## Shoalhaven Traffic Committee

**Meeting Date:** Tuesday, 14 March, 2023

### Agenda

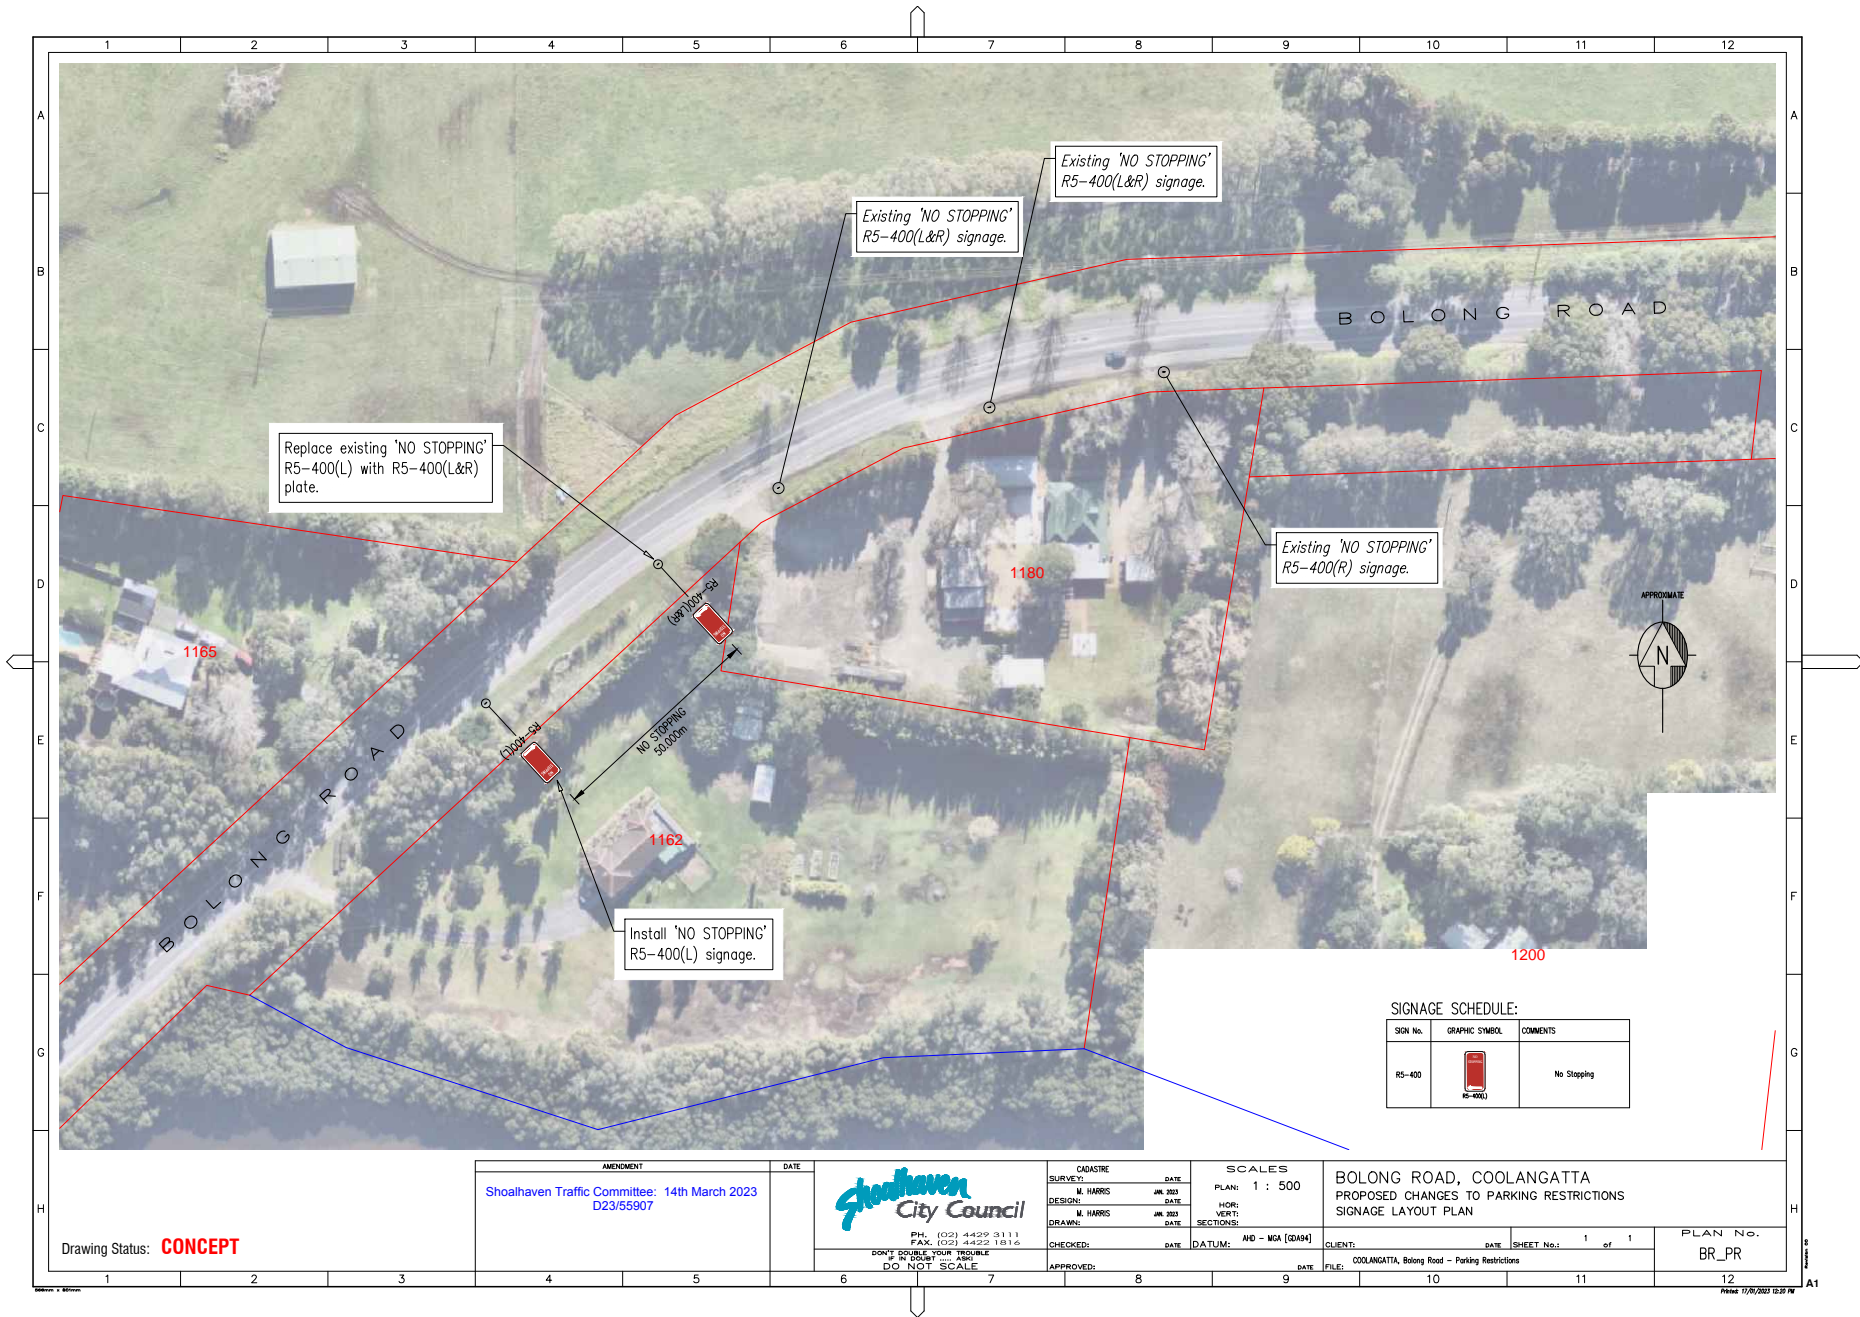
The extent of this proposal would involve installing additional “No Stopping” restrictions along the frontage of 1162 Bolong Road, extending the existing parking restrictions by approximately 50 metres.

1. the Chief Executive Officer (Director City Services) be advised that the Shoalhaven Traffic Committee has no objection to the proposed Parking Restrictions at Bolong Road, Coolangatta as per Plan No. D23/55907.
2. The recommendation be approved by the Director City Services under delegated authority from Shoalhaven City Council - refer MIN21.411

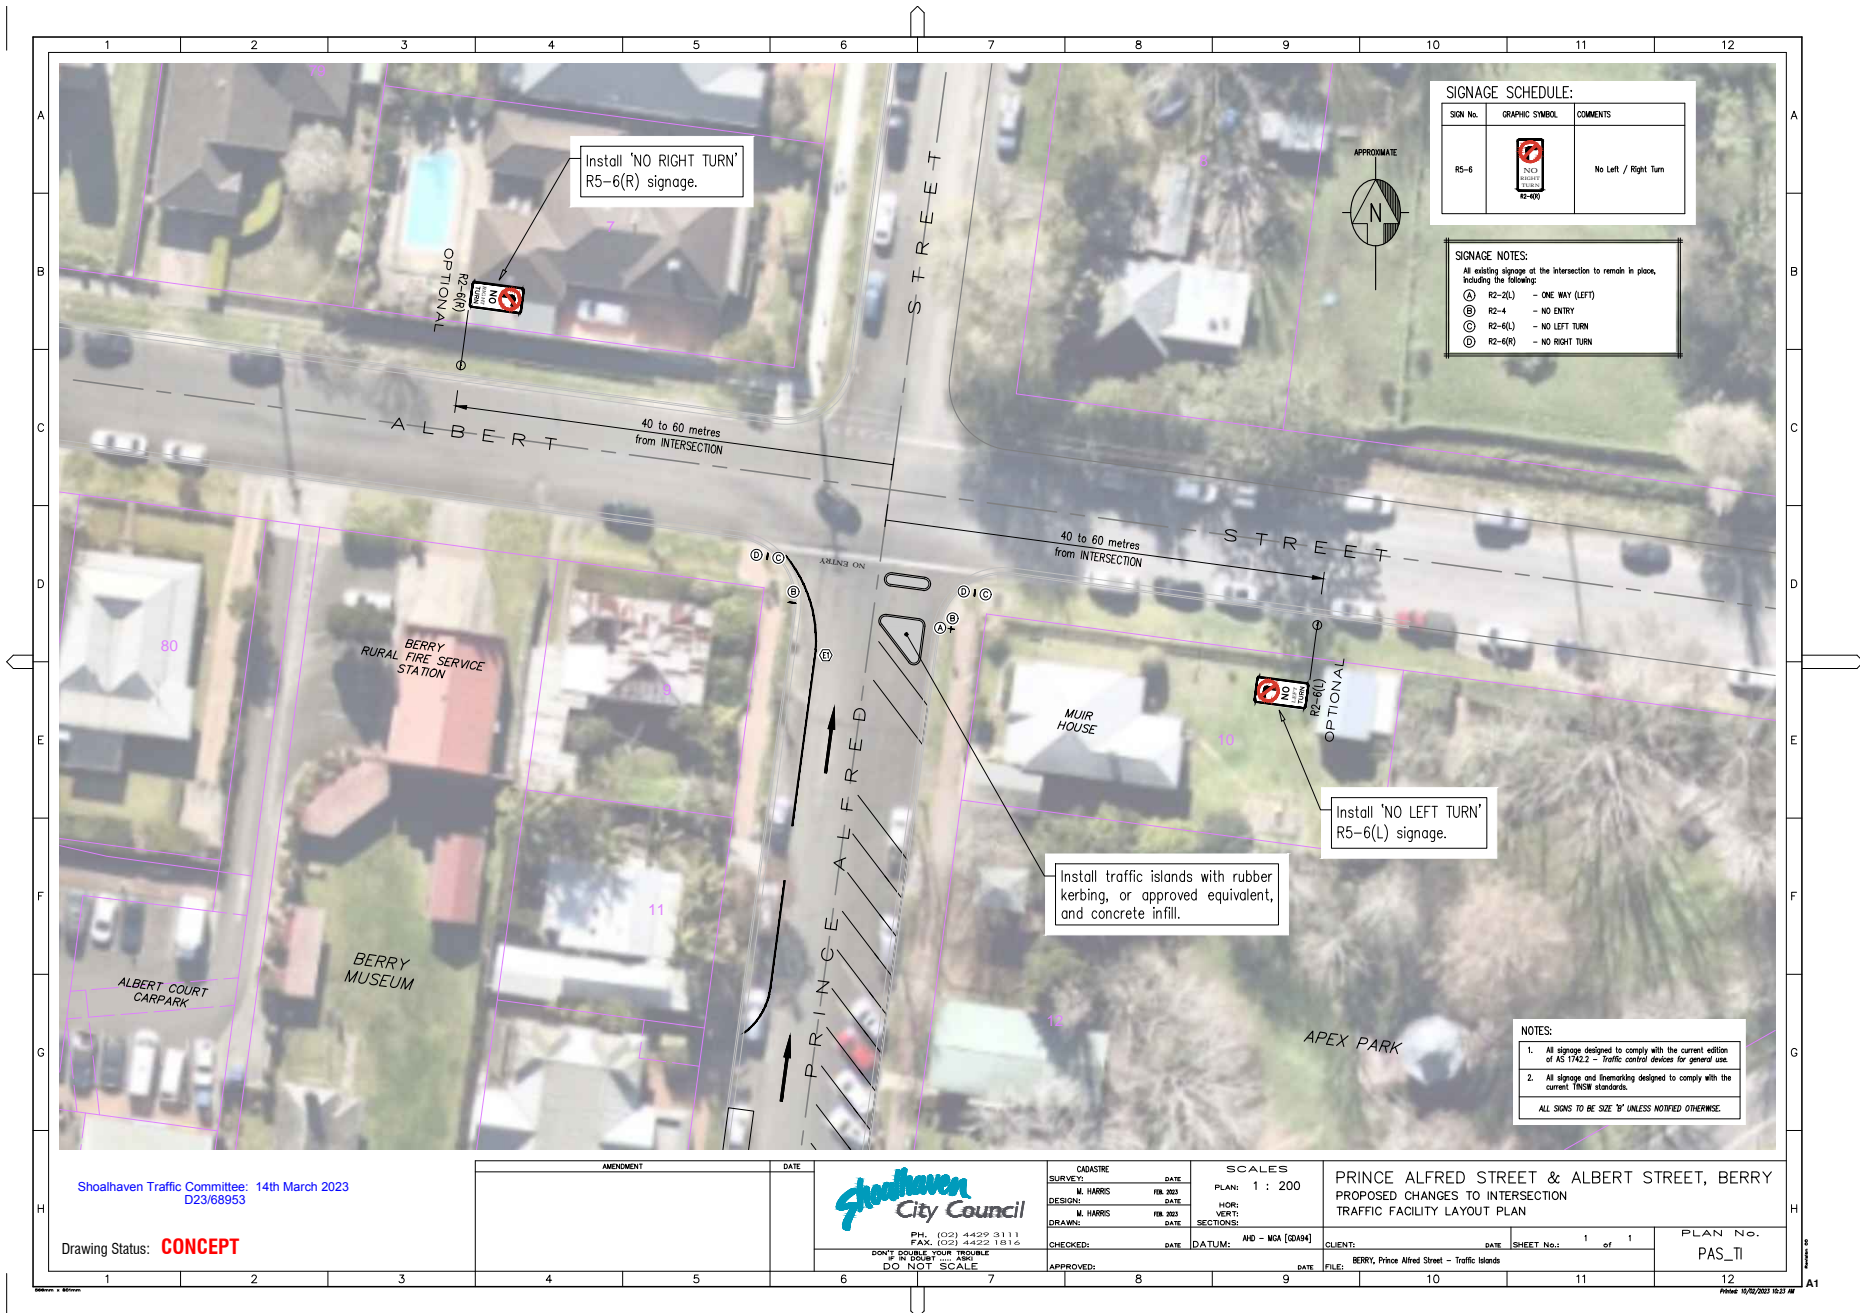
The extent of this proposal would involve the installation of two (2) concrete traffic islands at the intersection of Prince Alfred Street and Albert Street outside Muir House, with the option of the installation of “No Left / Right Turn” signage on the approaches on Albert Street.

1. the Chief Executive Officer (Director City Services) be advised that the Shoalhaven Traffic Committee has no objection to the proposed Traffic Facilities at Prince Alfred Street, Berry as per Plan No. D23/68953.
2. The recommendation be approved by the Director City Services under delegated authority from Shoalhaven City Council - refer MIN21.411

**Proposed Buses Prohibited Signage  
Booderie Avenue  
Hyams Beach**

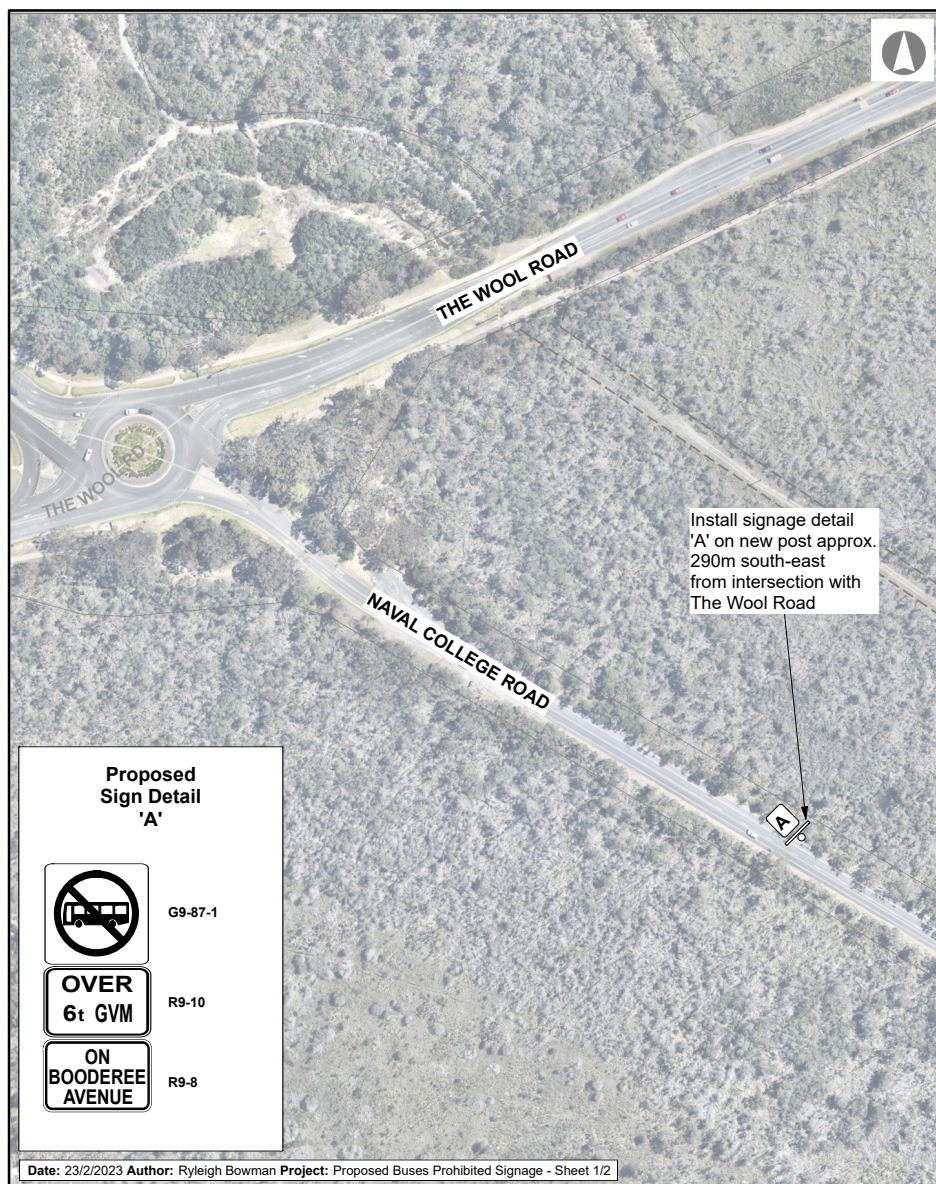
Install signage detail 'B' on new post approx. 175m north from intersection with Booderee Avenue

Install signage detail 'C' on new post approx. 24m from intersection holdline

Install signage detail 'B' on new post approx. 175m south from intersection with Booderee Avenue

1. The Chief Executive Officer (Director City Services) be advised that the Shoalhaven Traffic Committee has no objection to the proposed bus restrictions on Booderee Avenue, Hyams Beach and associated guide signage, as per Plan No D23/81051.
2. The recommendation be approved by the Director City Services under delegated authority from Shoalhaven City Council - refer MIN21.411.

Shoalhaven Traffic Committee: 14 March 2023  
D23/82135

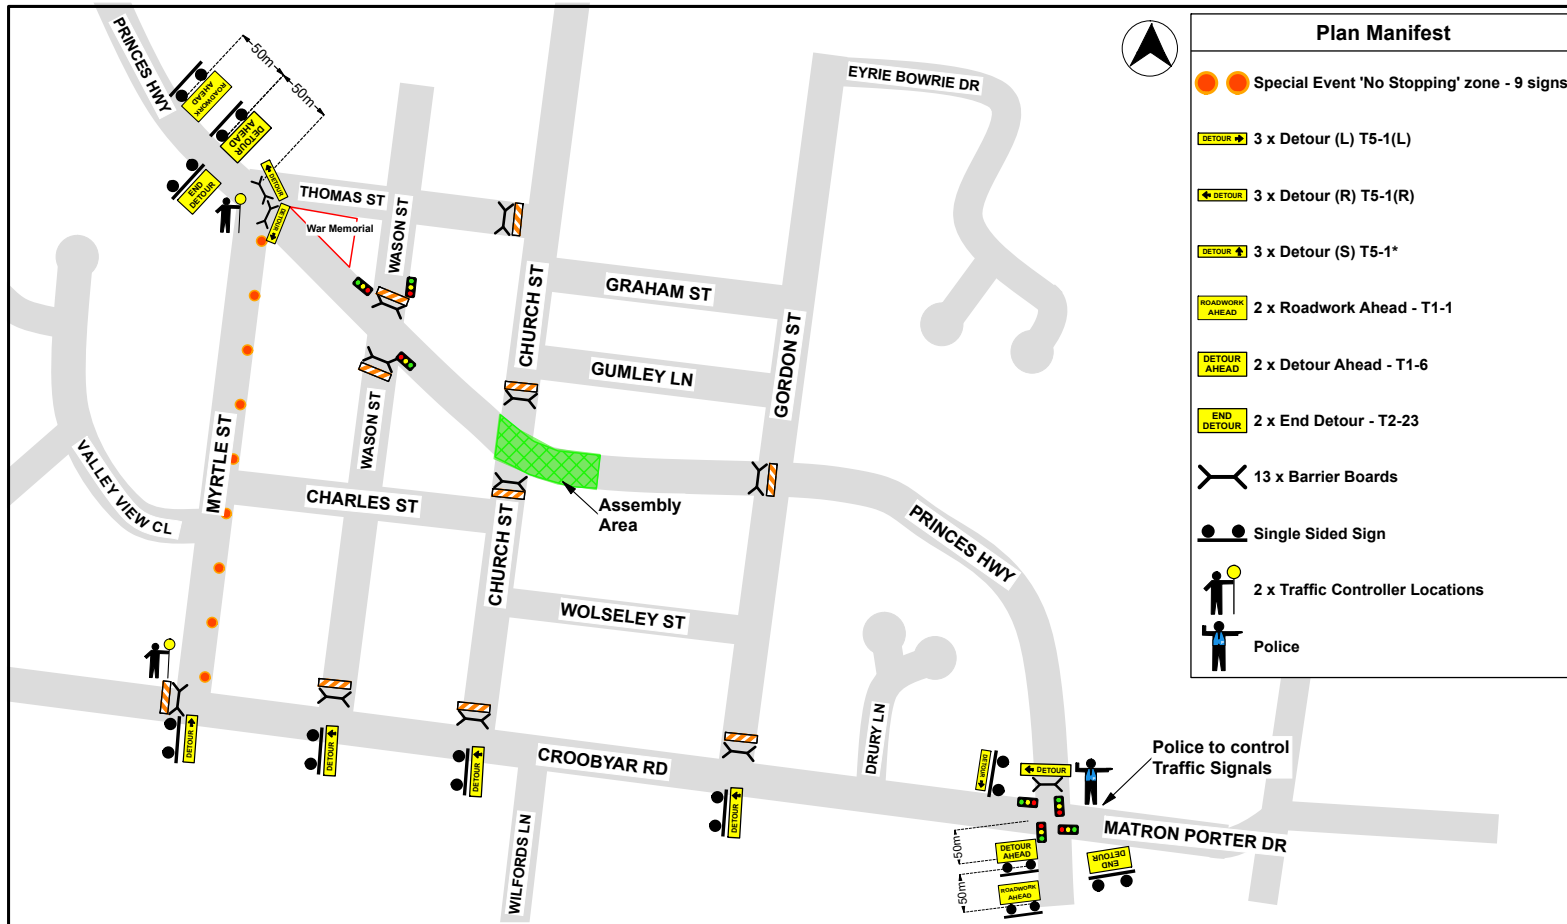
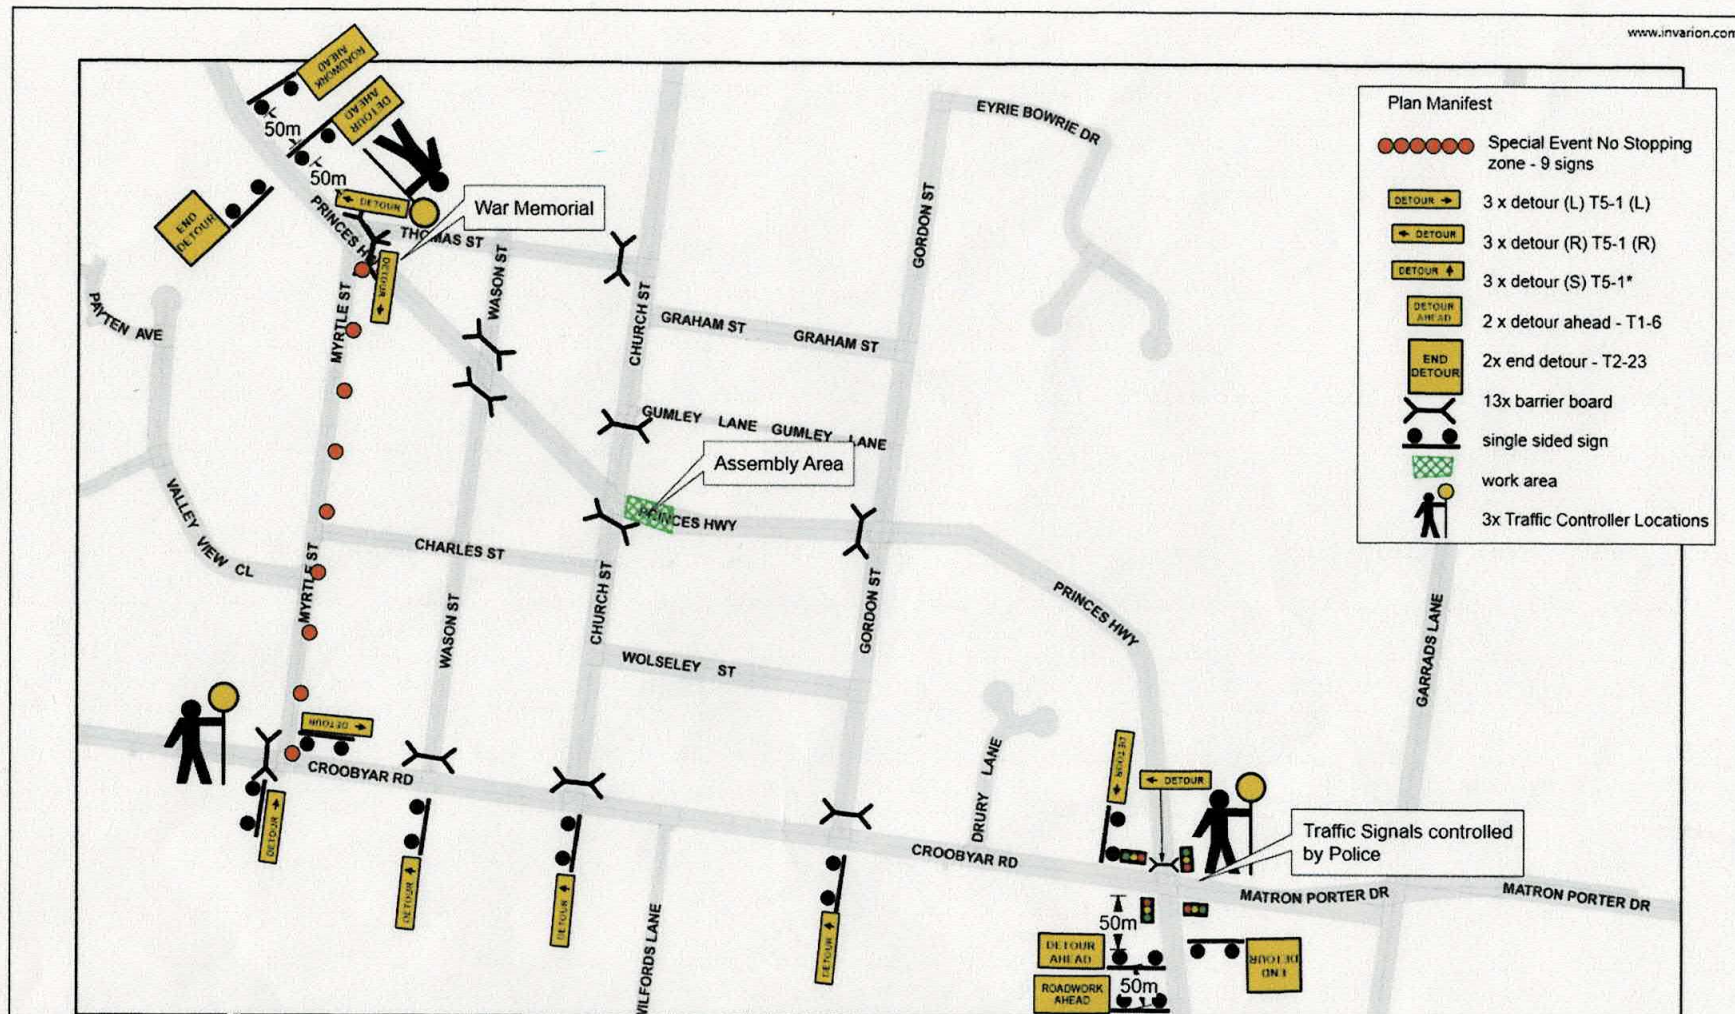
The proposed TGS (Attachment 1) has been updated from the previously endorsed traffic control plans (Attachment 2), bringing the technical references and layout of traffic control measures to current specifications. Similar to previous iterations of the Milton Anzac Day march, the proposed temporary road closures and traffic control measures will be in place between 10:30am to 11:30am on Tuesday, 25 April 2023.

1. The Chief Executive Officer (Director City Services) be advised that the Shoalhaven Traffic Committee has no objection to the proposed temporary road closures to enable the ANZAC Day march and commemorative service in Milton, held on Tuesday 25 April 2023, as per Plan No D23/82135.
2. The recommendation be approved by the Director City Services under delegated authority from Shoalhaven City Council - refer MIN21.411.
